Request for Class II Permissive Change(C2PC)

FCC ID: VG8EM025FXX-Y

1. Changed Mother -board as below.

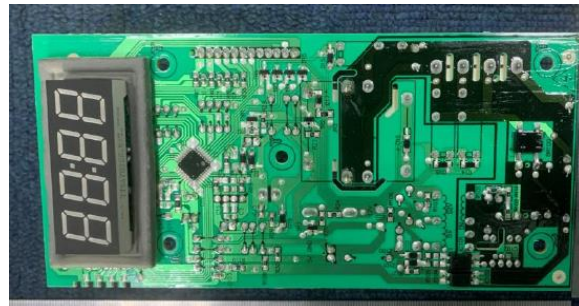
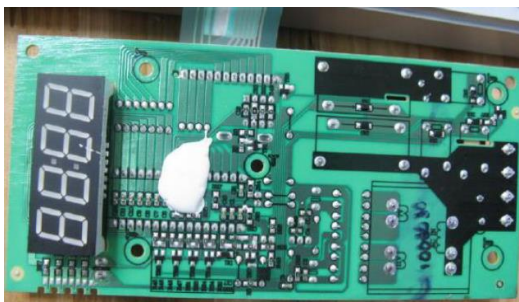
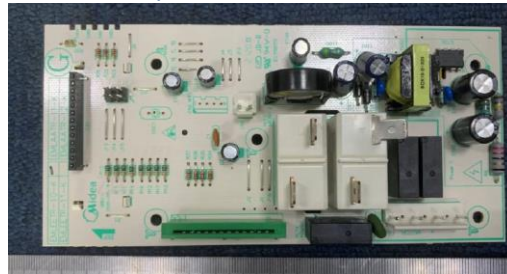
The original top /Bottom view

The new top /Bottom view

The new mother board is a switching power supply instead of the original linear transformer scheme. They have the same input, output and power except for PCB layout and some electronic component differences.
